**REPORT TO:** Committee of Adjustment

**REPORT NO.:** DSD-2025-285

**SUBJECT:** Minor Variance Application A2025-060 - 181 Borden Avenue North (Proposed Severed Parcel)  
Minor Variance Application A2025-061 - 181 Borden Avenue North (Proposed Retained Parcel)  
Consent Application B2025-019 - 181 Borden Avenue North (Proposed New Lot)  
Consent Application B2025-020 - 181 Borden Avenue North (Proposed Easement)

**Figure 3: The proposed site plan**

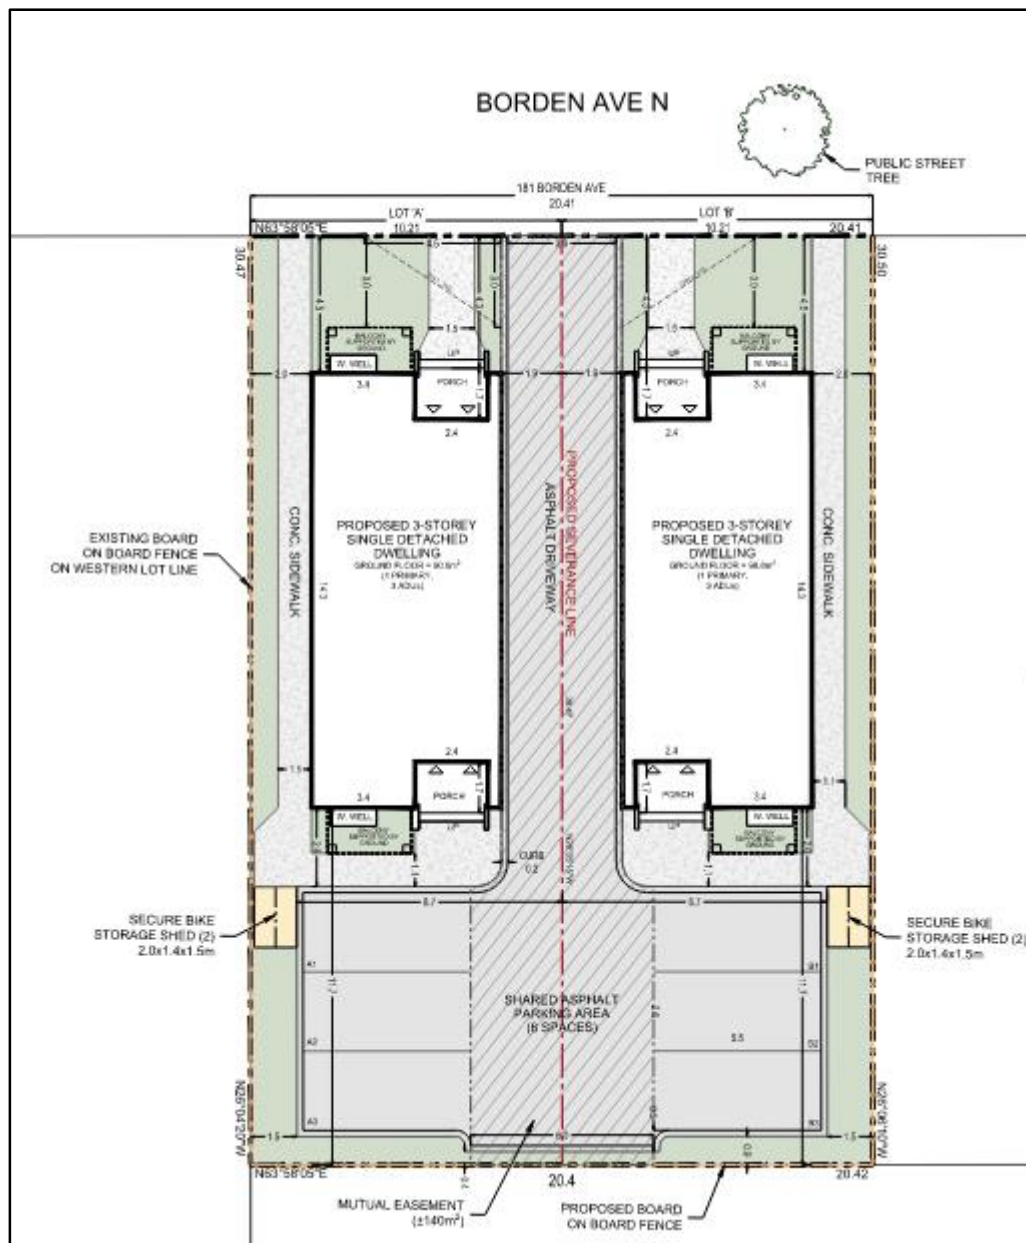
The proposed 1.5 metre front balcony projection supported by columns maintains the openness of the front yard while providing a functional outdoor amenity space that is compatible with the residential character of the neighbourhood, as the abutting mid-rise building has front balconies as per Figure 5. The structure is modest in scale and design, with columns that do not create a negative impact and do not create a significant massing effect as per the elevation drawing in Figure 6.

In this case, the proposed driveway exceeds the 8.0-metre limit to accommodate the required parking spaces. However, the property continues to meet the rear yard landscaping requirements of 30%, including a porch that leads to the rear dwelling and rear balconies on the second and third floor. These landscaped areas provide sufficient space for outdoor use and stormwater infiltration.

The driveway in the rear yard widens to 8.7 metres, which is only 0.7 metres wider than the requirement, and it is shared with the abutting lot through the proposed easement. Given this configuration, the impact of the increased driveway width is minimal, especially as it is located at the rear and not visible from the street.

In addition, the variance to permit a maximum driveway width of 8.7 metres in the rear yard is required to accommodate a shared driveway between the two properties, and the driveway accommodates rear yard parking spaces. The increased width is considered appropriate and meets the intent of the Zoning By-law in providing functional access while avoiding over-paving of the site.

- The Owner shall implement a suitable design solution for a sump pump outlet to the satisfaction of the Director of Engineering.
- The side yard currently accommodates overland stormwater flows from the rear yard. A sidewalk is required to the rear yard in accordance with the Zoning By-law. The final grading of this property shall not adversely affect the drainage of adjacent properties or the overall grading control plan. The Owner is responsible to address storm water drainage at the Building Permit stage.

**Figure 7: Proposed lot Fabrics**

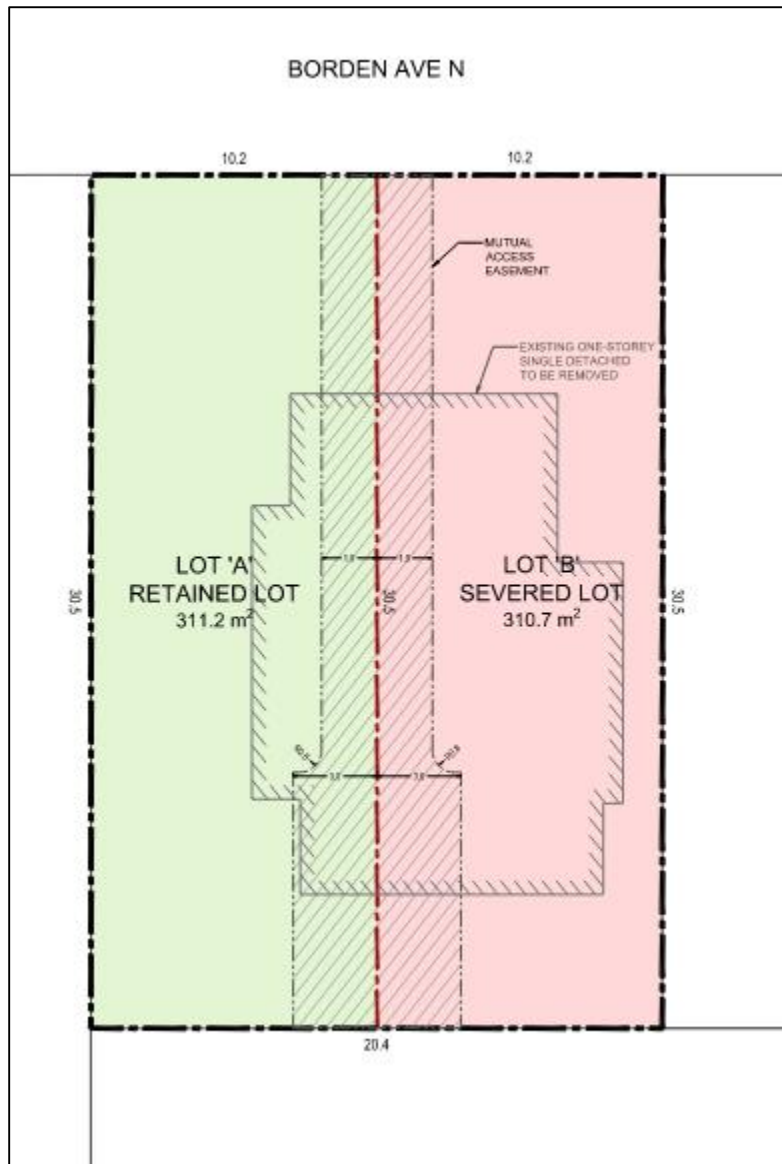
In satisfying 17.E.20.5.b), a mix of lot fabrics are found in the area. The existing lot is generally larger than those observed in the area, and the proposed lots are generally reflective of the lotting pattern of the area, particularly the narrower properties along East Avenue.
